CITY OF PORTLAND, MAINE  
DEVELOPMENT REVIEW APPLICATION  
PLANNING DEPARTMENT PROCESSING FORM  
DRC Copy

Project Name/Description

RE: 88 Verrill Street (CBL 300B029/ ID 2001-0074)

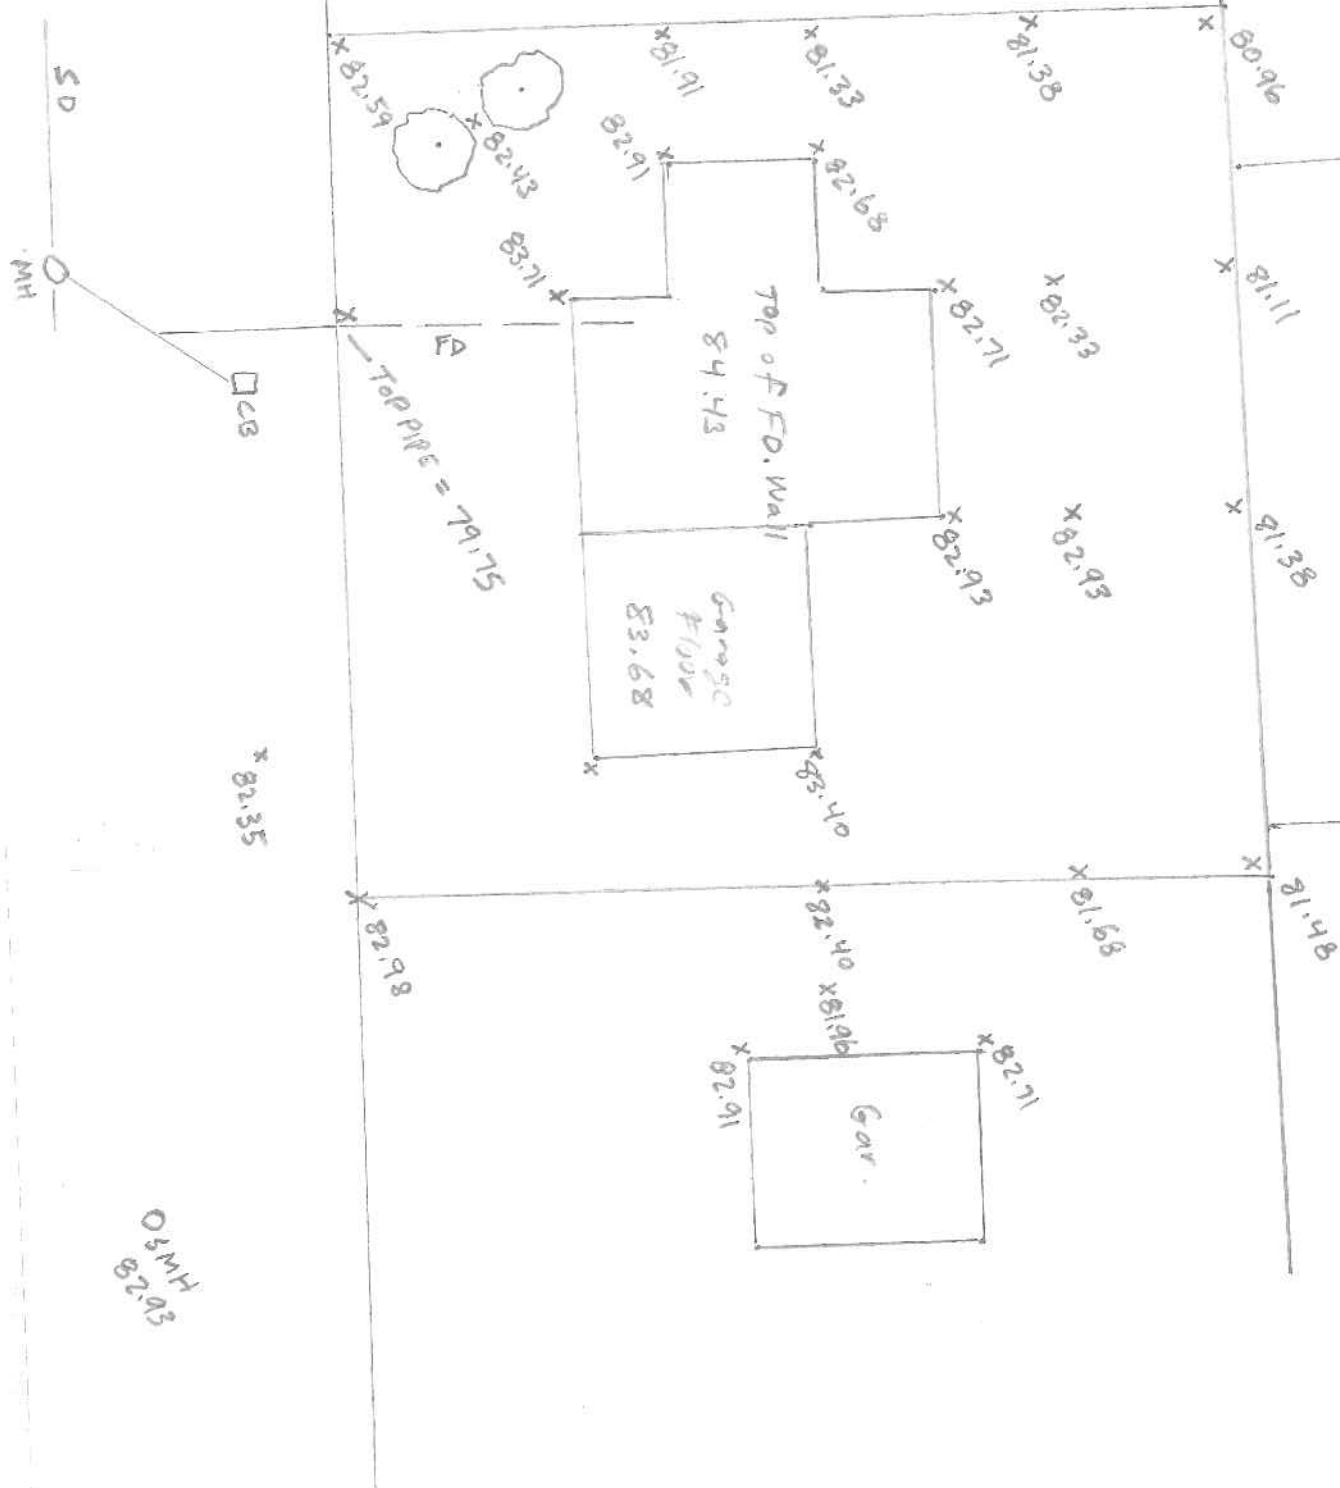
Enclosed please find the sketches showing the details to be used to construct the proposed drain structure. Also please take note on page 1 of the spot elevations as they currently exist today. For the most part they are as I proposed on the site plan. On page 2 note the flow arrows, which are proposed and will direct all water towards the drain structure. And on page 3 the details showing the pressure treated basin, which will be used to collect the water before it leaves the lot. And lastly note the 4" pipe run at 1/8" per foot for approx. 80' or 10" in depth to the surface water drain located at the property line and sidewalk. This drain will also be connected to the gutter as it passes the two corners of the house as shown on page 2. My plan is to install the proposed drainage system in early Nov. If you have any questions please call me. Thank you for your help. Paul

After review of the recent submittal for the 88 Verrill Street site plan, I found the proposal to address drainage to be acceptable.

The one condition of this approval is that the drainage improvement, which includes pipe, basin, and grading, will be done during this construction season (before winter). This was discussed and agreed upon previously at our on-site meeting with Alex Jaegerman and Sarah Hopkins of the Planning Department.
